## Proposal for amendments to

### **ECE/TRANS/WP.29/2020/81 complemented by ECE/TRANS/WP.29/GRVA/2020/32 and ECE/TRANS/WP.29/GRVA/2020/33**

The text reproduced below was prepared by the experts from the EC. The proposal is aimed at modifying the text of document ECE/TRANS/WP.29/2020/81 (Regulation 157 on ALKS) as amended by ECE/TRANS/WP.29/GRVA/2020/32 and ECE/TRANS/WP.29/GRVA/2020/33. All modifications to ECE/TRANS/WP.29/GRVA/2020/32 and ECE/TRANS/WP.29/GRVA/2020/33 are given in **red** text. Modifications to the original text of ECE/TRANS/WP.29/2020/81 (Regulation 157 on ALKS) are given in **bold**. Deletions are indicated by ~~red strikethrough~~ text.

Figure 1

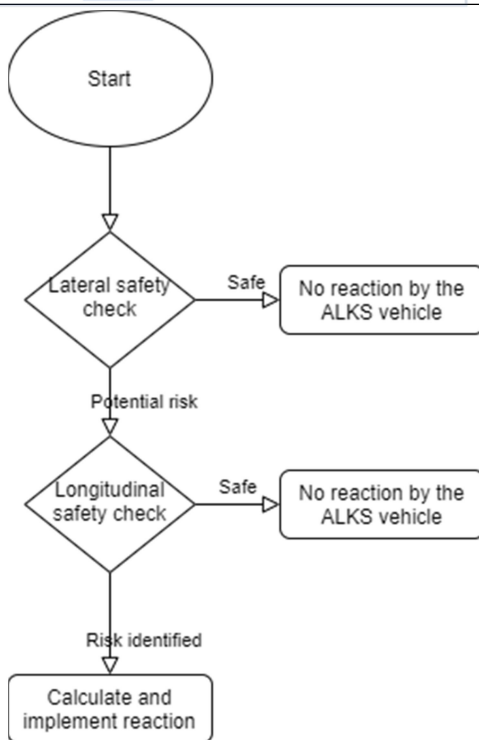
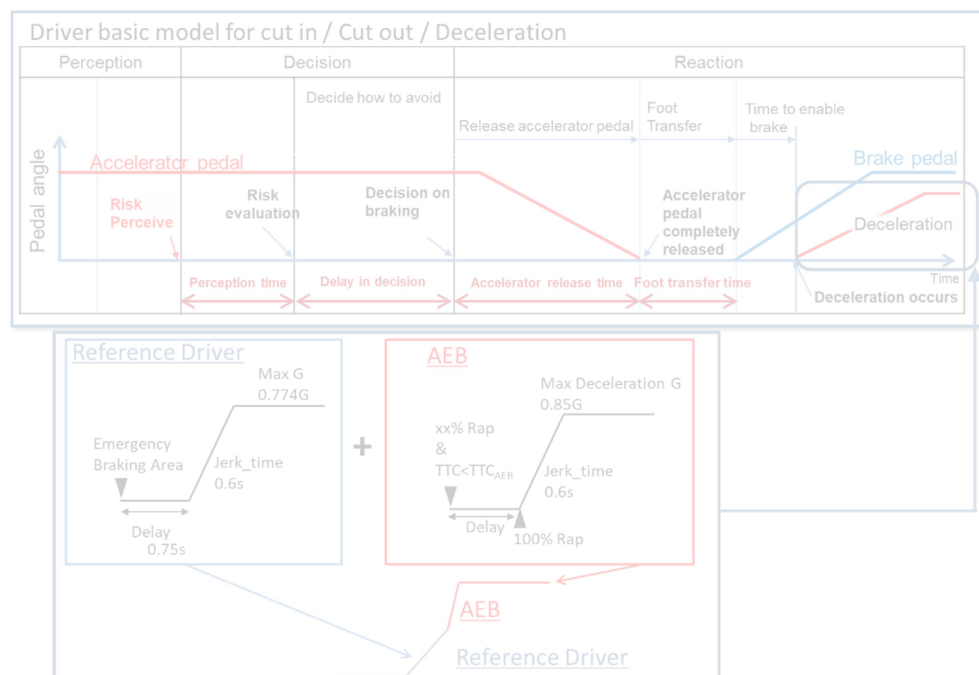
- 3.2. ~~In a low speed ALKS scenario, the avoidance capability of the driver model is assumed to be only by braking.~~ The driver model is separated into the following three ~~steps segments~~: "~~Pereception~~ **Lateral Safety Check**"; "~~Longitudinal Safety Check Decision~~"; and, "Reaction". **A Reaction is implemented only if the Lateral and Longitudinal Safety Checks identify a risk of imminent collision.** The following diagram is a visual representation of these ~~three steps segments~~:

**3.2.1 The Lateral Safety Check identifies a potential risk of collision if the following conditions hold true:**

3.2.2 The Longitudinal Safety Check requires the assessment of two Fuzzy Surrogate Safety Metrics, the Proactive Fuzzy Surrogate Safety Metric (PFS), and the Critical Fuzzy Surrogate Safety Metric (CFS).

3.2.3. If a risk is identified the ALKS vehicle is assumed to plan and implement a reaction by decelerating according to the following equation:

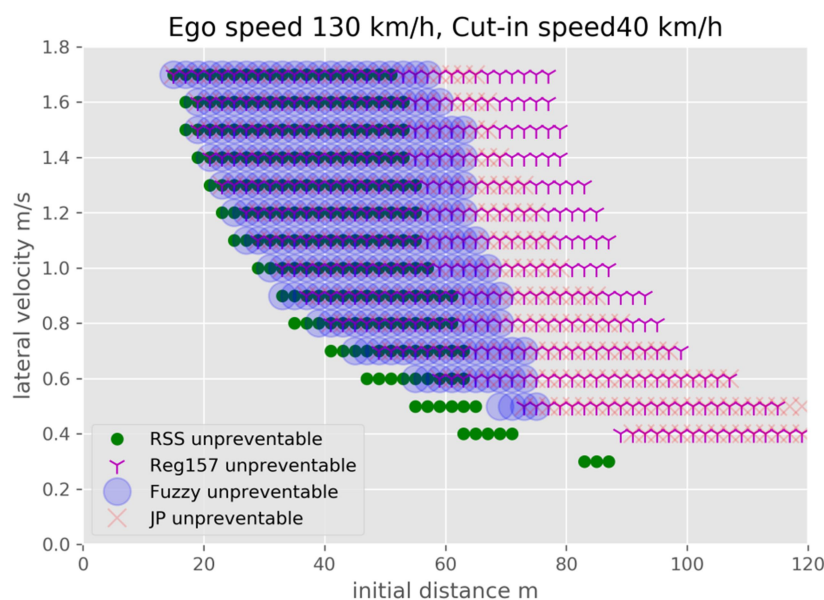
The Figure above shows a comparison of the unpreventable situations identified by the current requirement (referred to as Reg157), by the current model in Appendix 3 of Annex 4 (referred to as the JP model), by the RSS model and by the Fuzzy-based approach proposed in the present amendment, for the case of an ego vehicle proceeding at 130km/h and having another vehicle cutting-in at 40km/h. All the models use the same hypotheses in terms of reaction time and deceleration
